X-600 firmware version 3.01

This zipped folder contains the files and instructions to upgrade your X-600 fluxer with the current firmware (operating system) version 3.01.

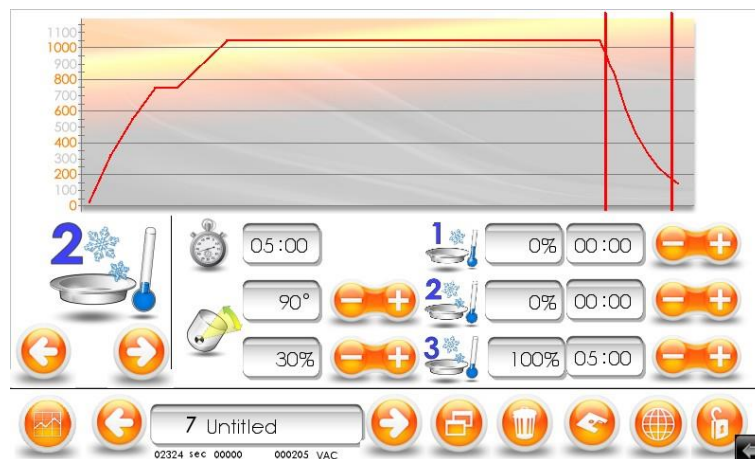
- New "Data Sampling" feature added. It gives the ability to log every fusion cycle with the samples IDs and generate a report for each day, up to a possibility of 40 days data recovery. The data sampling activation can be done by unlocking the system (password 2014) and it is located in the global parameters. A button will appear in the main window to access the data sampling window.

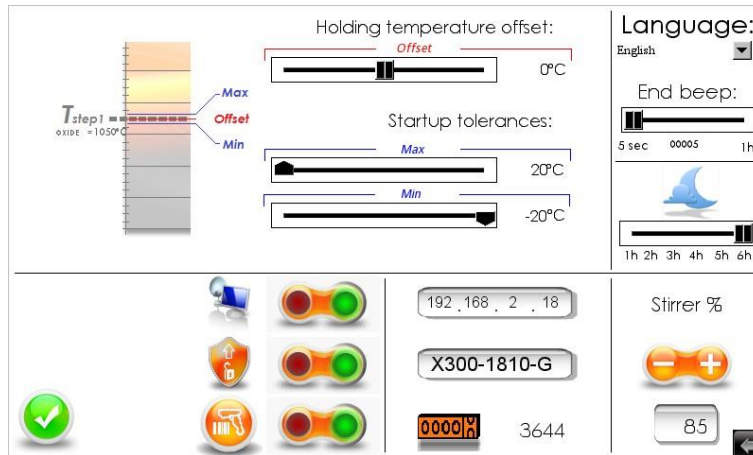
- New information fields, showing the serial number of the unit and the fusion counter in the global parameter window.

- Various labels in the global parameter window have been replaced by icons in order to reduce the amount of text. The “security shield” and the “moon crescent” icons are linked with the same feature as before (i.e. activating/deactivating the security shield in order to start a fusion, and setting the delay for an automatic shutdown to occur, respectively).
